Hollow Brook
Golf Club

Re: Hollow Brook Golf Club Water Monitoring Program

RE: Hollow Brook Golf Club
Cortlandt, New York

WATER QUALITY SAMPLING LOCATIONS

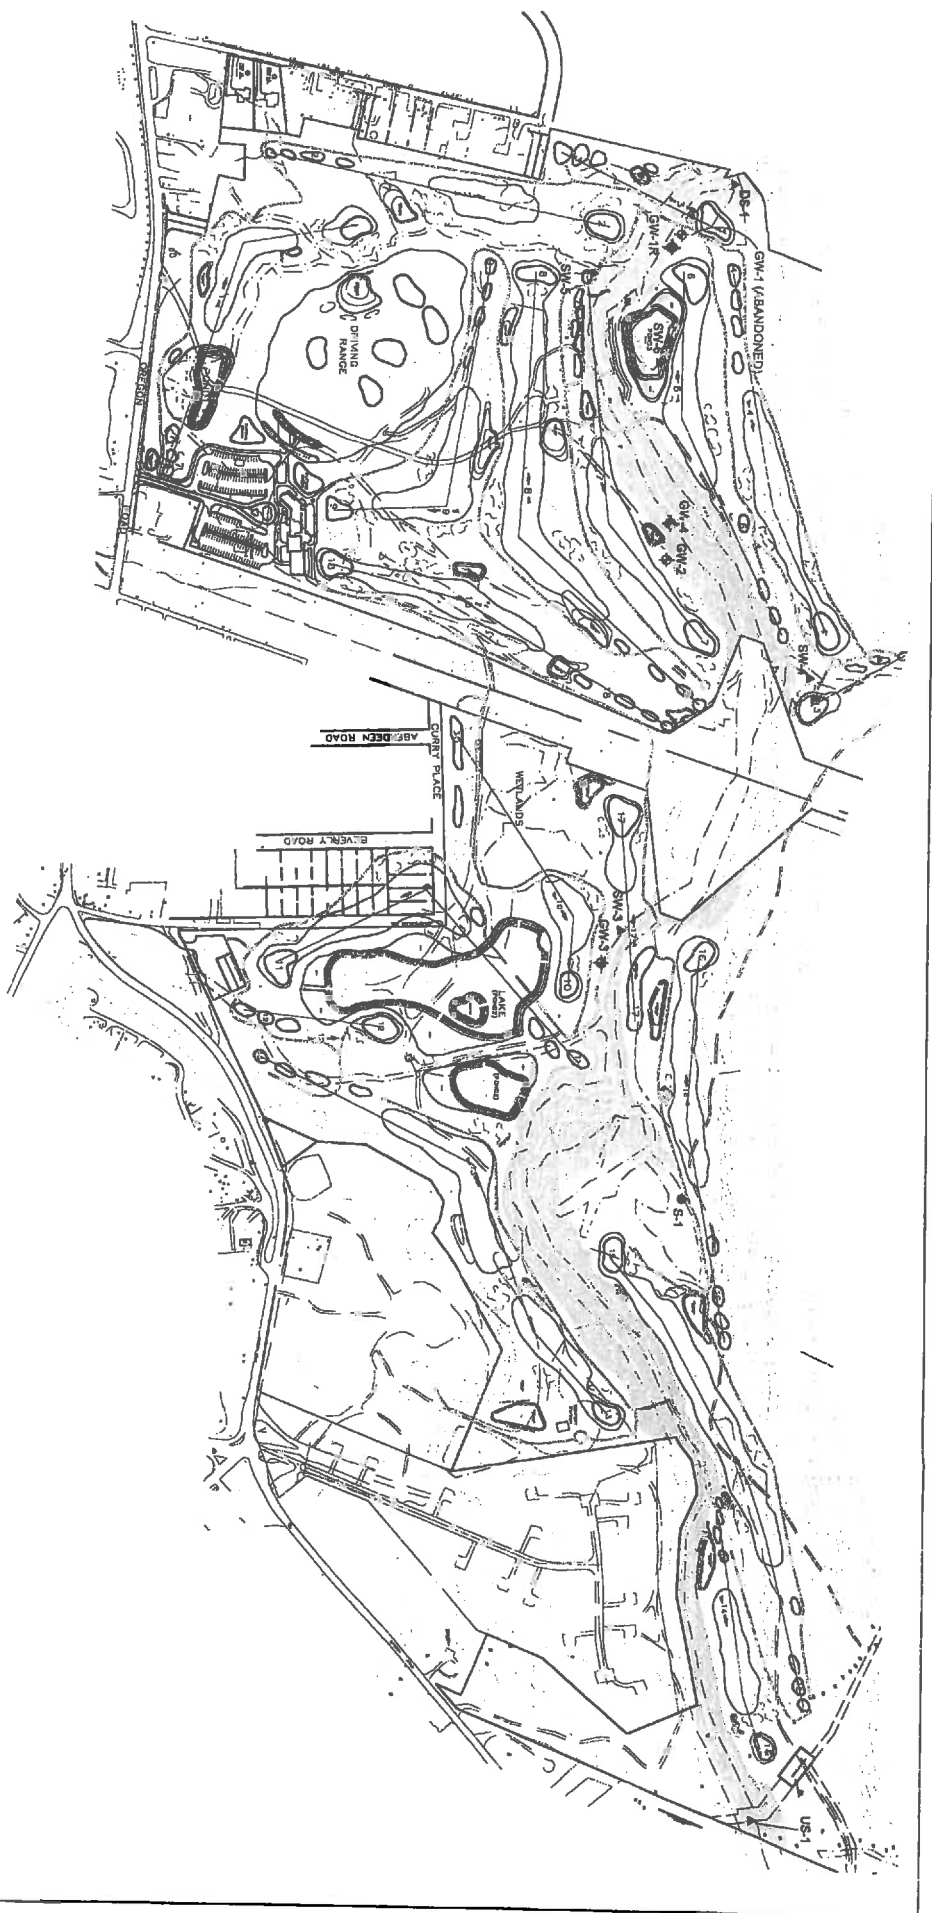
1) **Eliminate surface water sampling locations US-1 and SW-4**

Sampling point US-1 is located in the Hollow Brook, upstream of the Golf course and therefore it is not affected by the course. This location was monitored to assess surface water quality prior to flowing past the course property. Since the beginning of the program there has not been a significant detection at this location.

Sampling point SW-4 is located in a north to south flowing tributary that receives runoff from a small portion of the course on the north side of the Hollow Brook. In accordance with the Environmental Management Plan (EMP) for the course, samples from SW-4 are not analyzed for pesticides and SW-4 is not sampled during storm events. As a result, this location does not provide much useful data and there has not been a significant detection at this location over the last ten years.

2) **Replace groundwater sampling location GW-2**

Well GW-2 is located in a low-lying area at the edge of a water-quality basin off the 7th fairway. This area is prone to flooding during rain events and the top of the well is set slightly below grade level. Sampling results for this location have indicated that groundwater quality is likely influenced by surface water infiltration through the water quality basin and flooding around the well head. As a result, Well GW-2 has been replaced by new Well GW-4, which is located further away from the basin between GW-2 and the Hollow Brook. With Well GW-4 in place, sampling of GW-2 is no longer necessary.

3) **Discontinue analyses for volatile organics, PAHs and metals**

These parameters include petroleum related chemicals and naturally occurring metals. These chemicals are not pesticides and are not used in any manner as part of the turf management program. Over the last ten years there have not been any detections of these parameters that can be attributed to golf course activity and we see no benefit to continuing these analyses.
